Contract #: **04-0120E4**
Cty **SF** Rte **80** PM **13.4,13.8**
File # **13 .25 B**

QUALITY ASSURANCE - NONCONFORMANCE REPORT

Prime Contractor: Kiewit, FCI & Manson Joint Venture **NCR #105**

Subject: Response to Submittal No. 880, Revision No. 00 (Oregon Iron Works Response to NCR Generated by State Letter 1517)

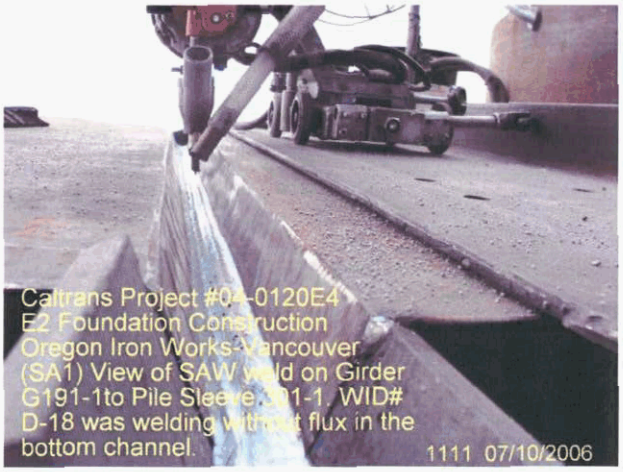
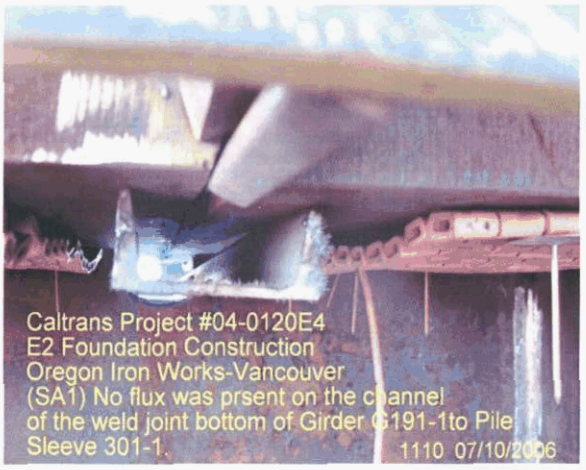
Description of Non-Conformance: Oregon Iron Works (OIW) Quality Control allowed OIW Welder Shannon Doolittle welder identification D-18 to perform welding outside the parameters of the Oregon Iron Works Welding Procedure Specification 4226. The welding was being performed without a flux-filled channel as described in the above mentioned welding procedure specification (WPS). Welding was performed with the submerged arc welding process on the South Pod Assembly (SA1) – Girder 191-1 to Pile Sleeve 301-1. *Attached pictures from this observation.*

Applicable reference: AWS D1.5-2002, Sec.5.21.2, OIW WPS 4226, Contract 04-012024 Special Provisions Section 8.3.

15. NCR 105 was issued on July 10, 2006 to document the Contractor welding outside the parameters of the WPS for the connection of G191-1 to Pile Sleeve 301-1. The

WPS requires a flux filled channel as backing for the weld joint; however, the channel did not contain any flux. As stated in OIW's response letter to State Letter 05.003.01-001517, dated September 7, 2006, the Contractor performed a deeper backgouge to ensure the root and butter passes were removed before depositing subsequent fill passes. METS agreed to this proposal and has verified the repair. METS considers this NCR to be resolved at this time.
